Richfield Planning Commission Agenda

a. Public hearing to consider a request by Minnesota Independence College & Community for a rezoning, Conditional Use Permit, Preliminary Plat, and variances.

MICC ARC Letter
11-21-25
Page 4

Encl: Engineering plan mark-ups & General Fire Protection Comments

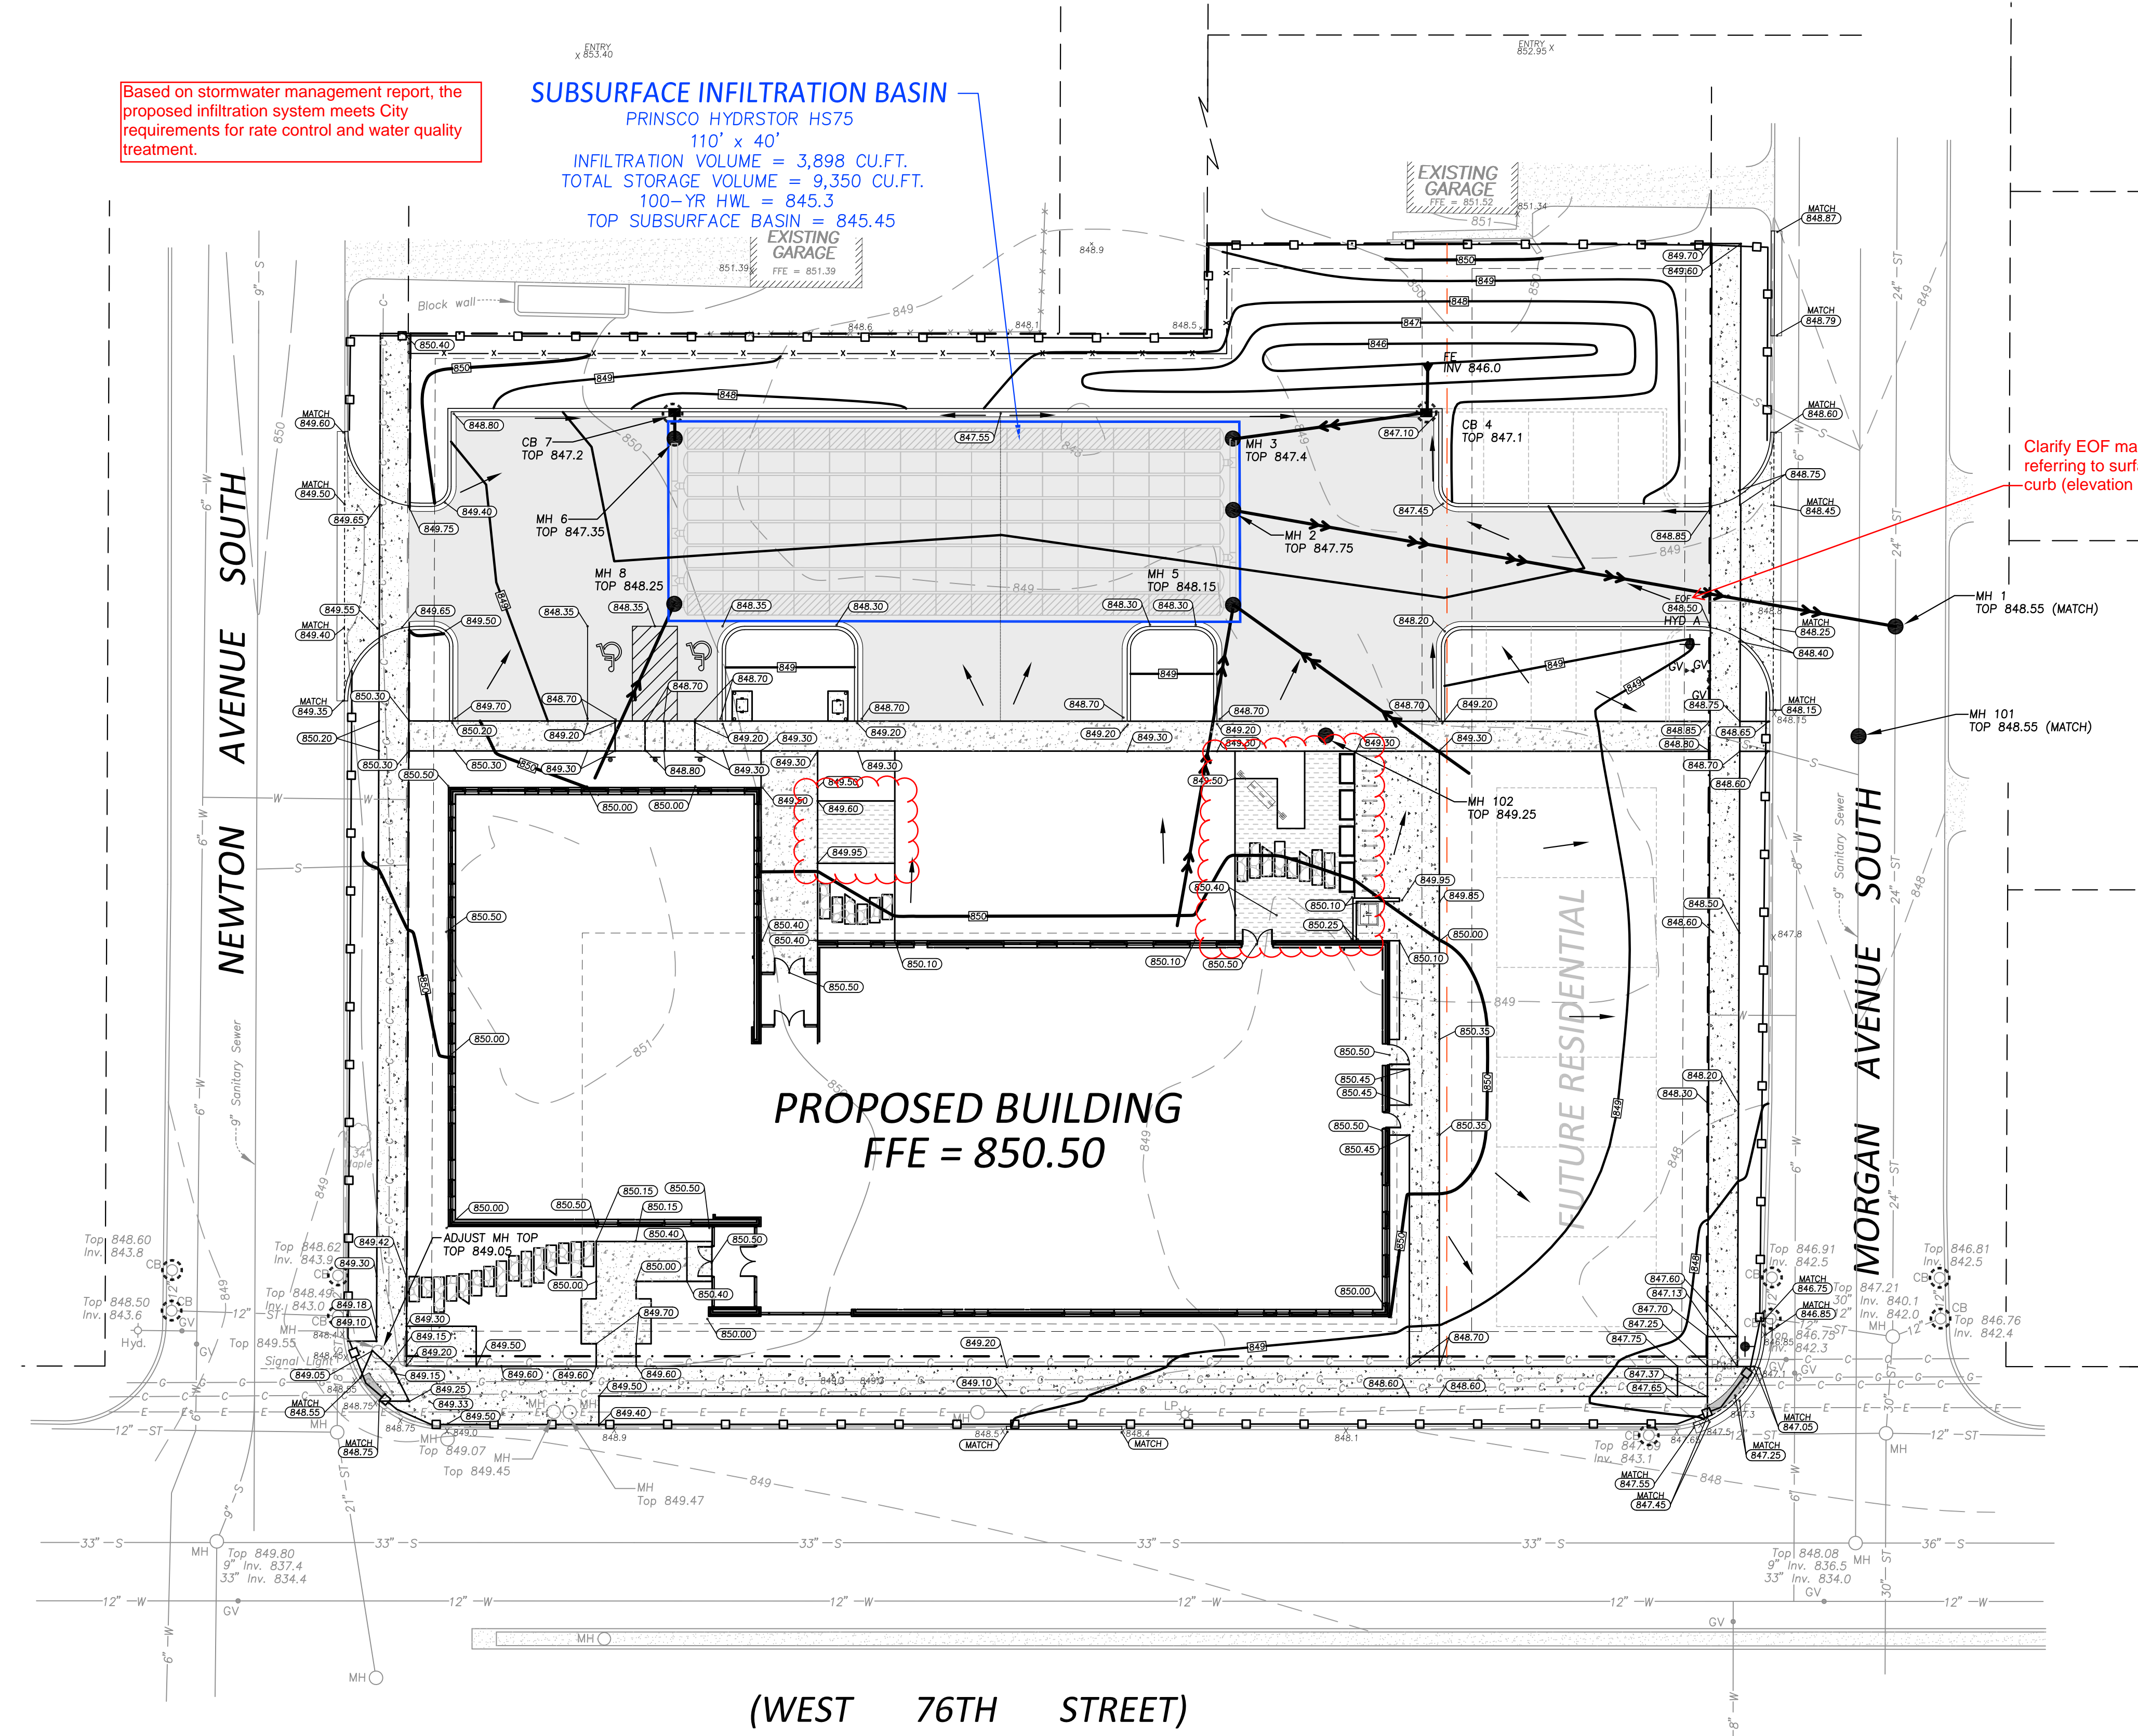
Clarify EOF marking - is this referring to surface flow along the curb (elevation marking 848.5)?

Site is within Nine Mile Creek Watershed District (NMCWD). Must obtain necessary approvals from NMCWD and provide copy of approvals.

Disturbed area exceeds 1 acre - must obtain coverage under MPCA State Construction Stormwater Permit and provide copy of approval.

Please show location of proposed rock construction entrance on grading, drainage, & erosion control plan.

Provide detail for proposed permeable pavement/surface in garden area North of building. Provide temporary and permanent soil stabilization methods (mats, fiber blankets, hydromulch, etc.) and location.

GRADING, DRAINAGE & EROSION CONTROL PLAN

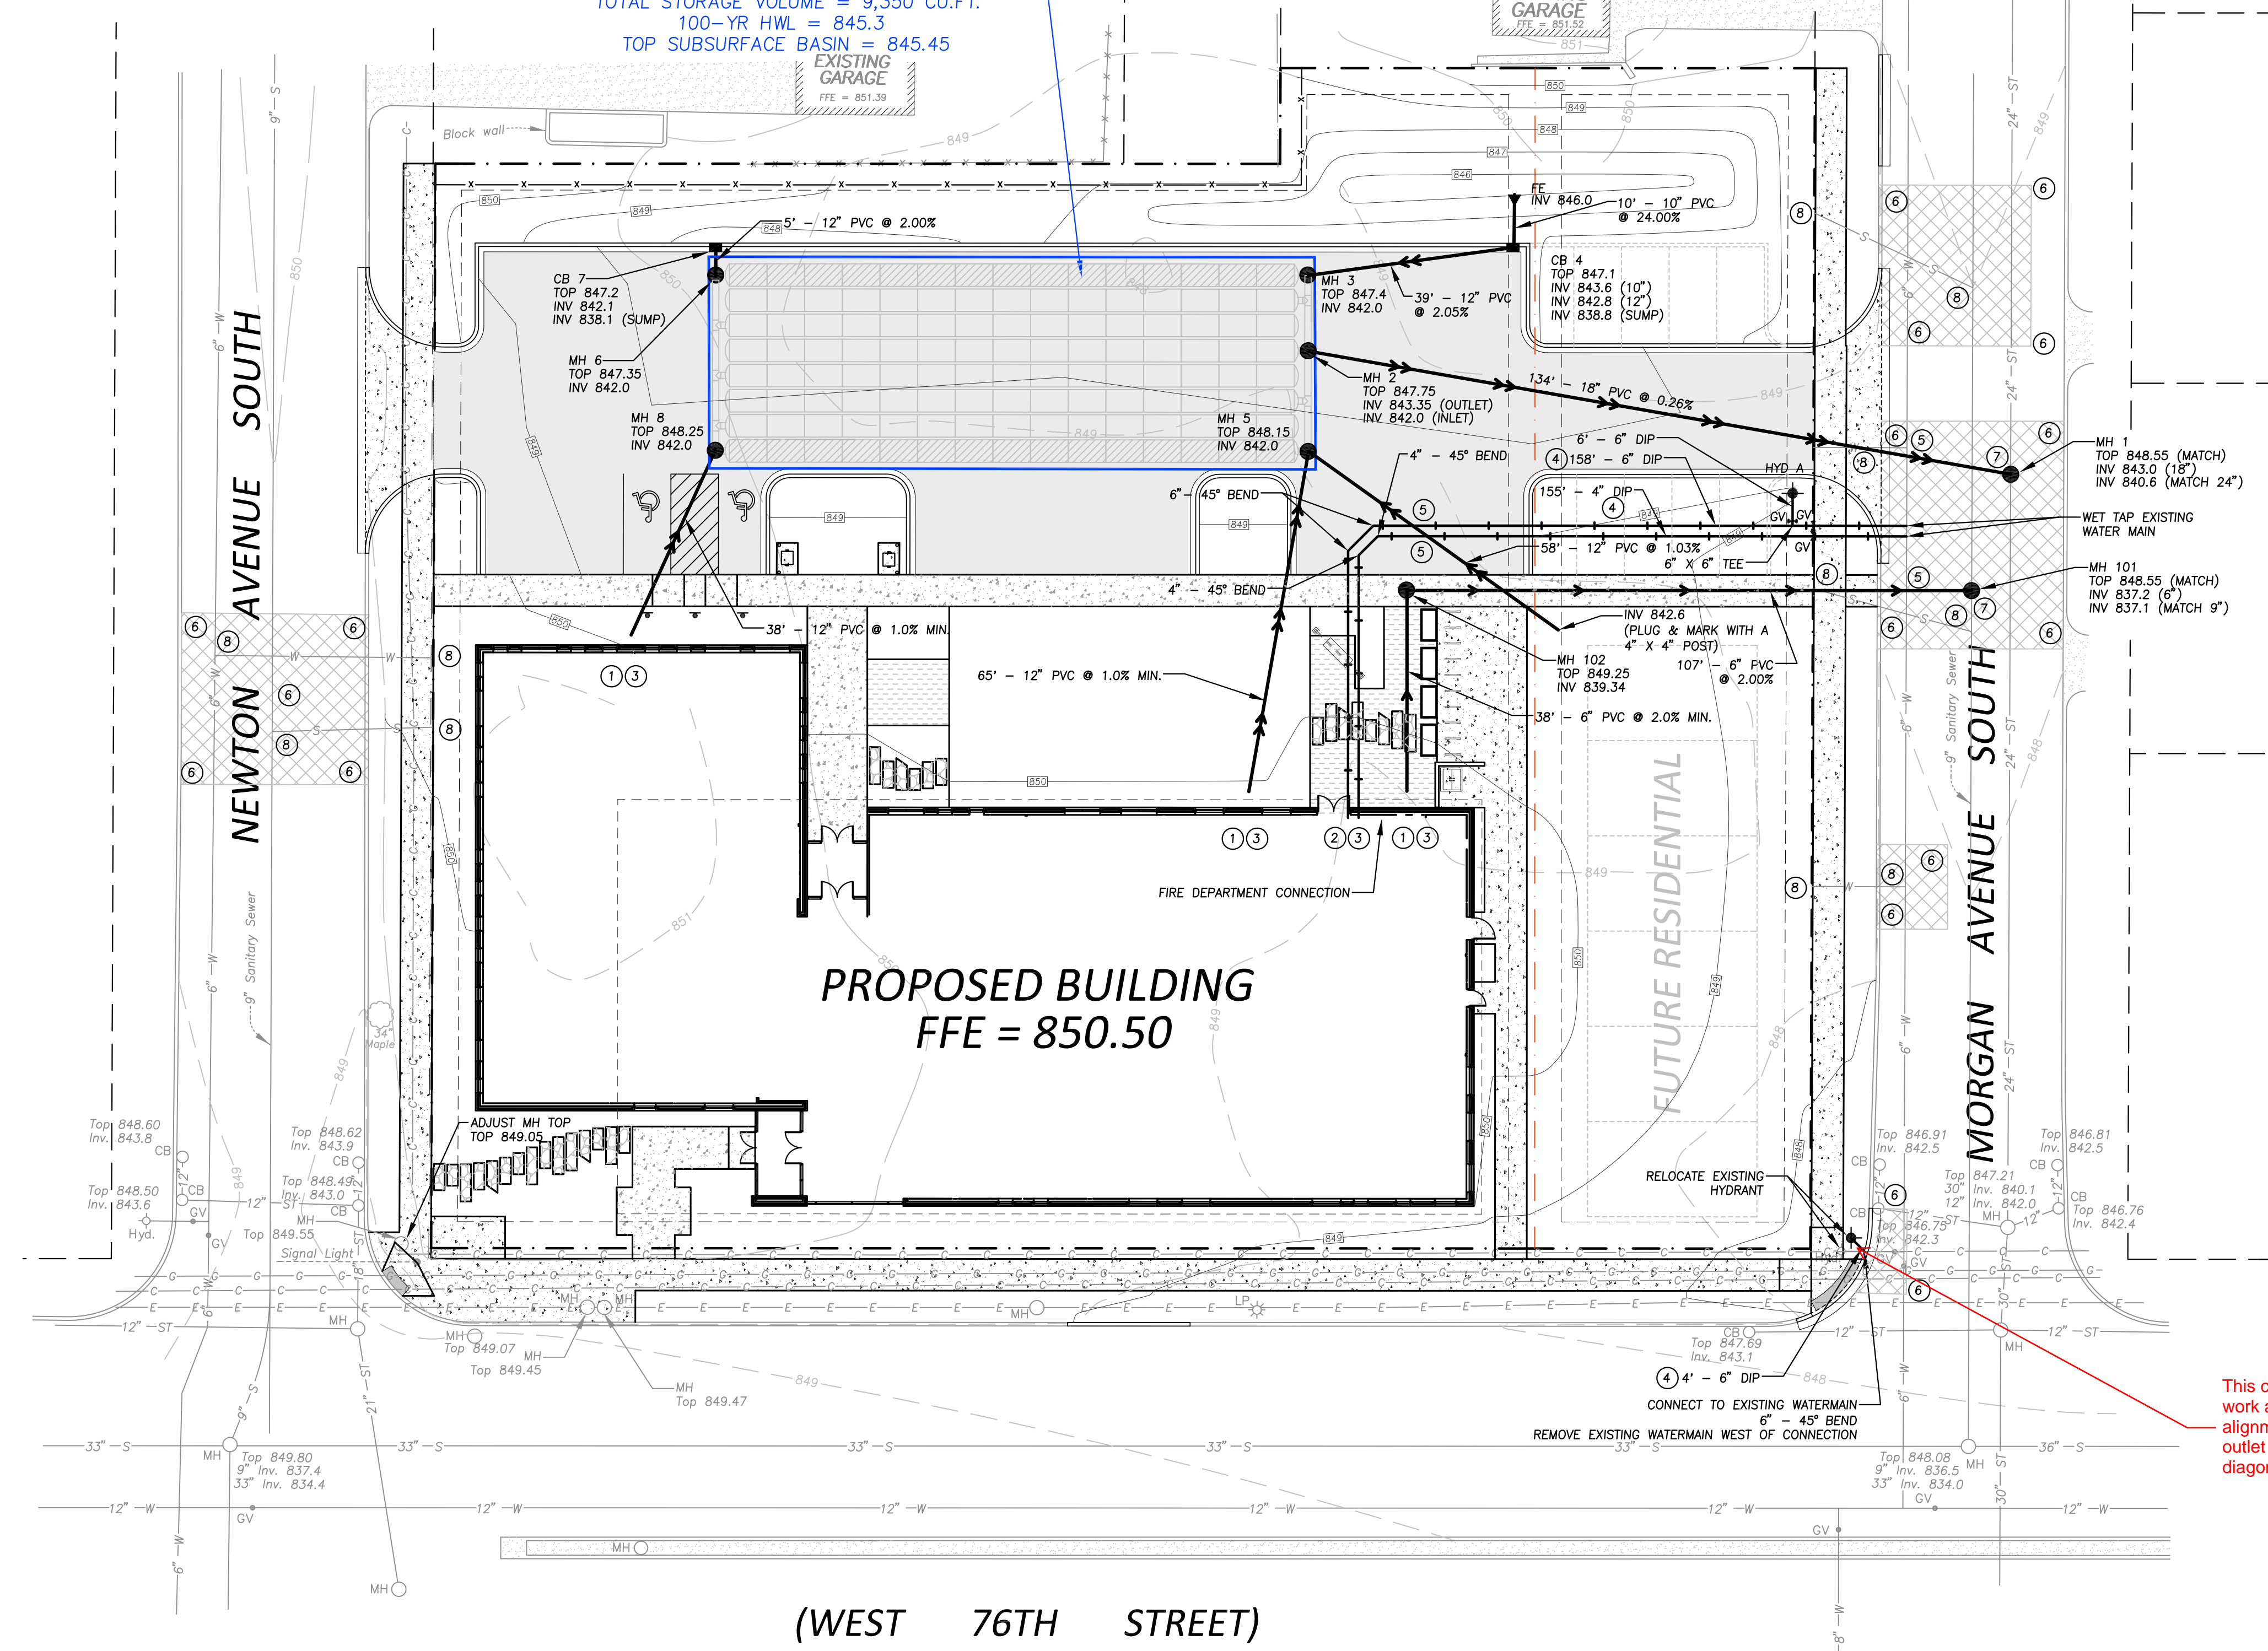
This connection won't work as shown, alignment of pumper outlet would be diagonal.

SWPPP

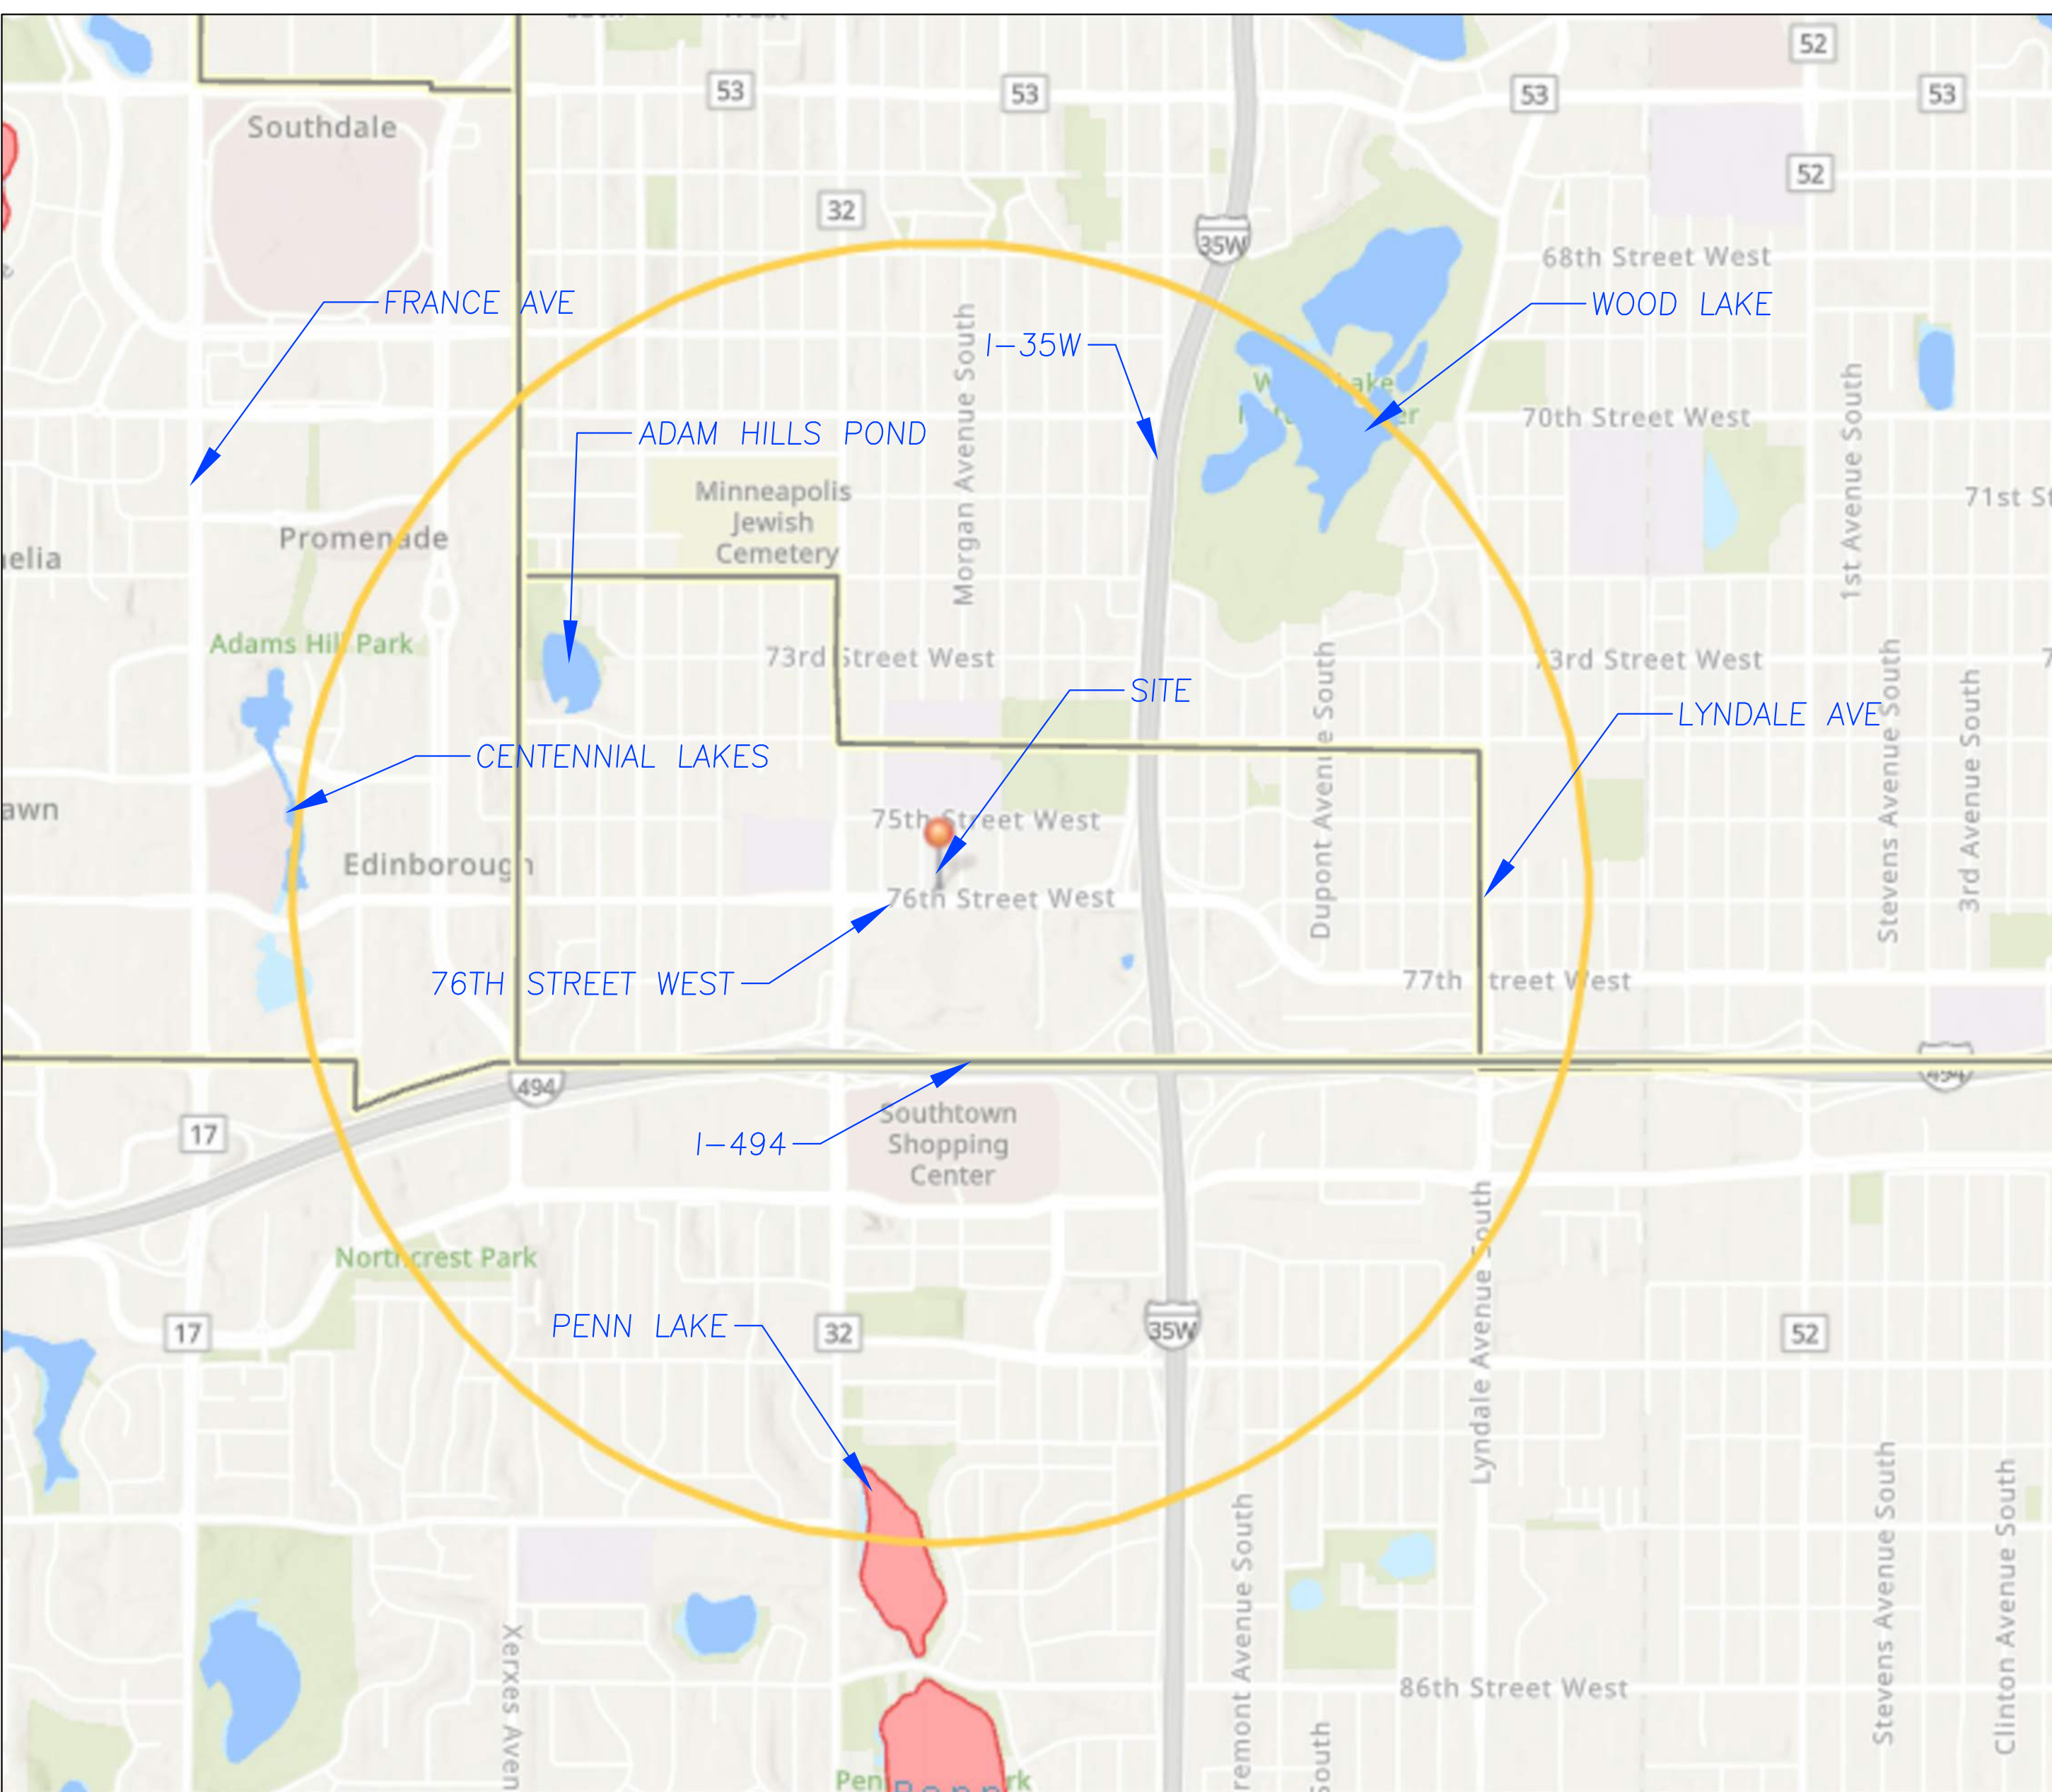
Provide est. quantities for soil stabilization BMPs (see note on C300)
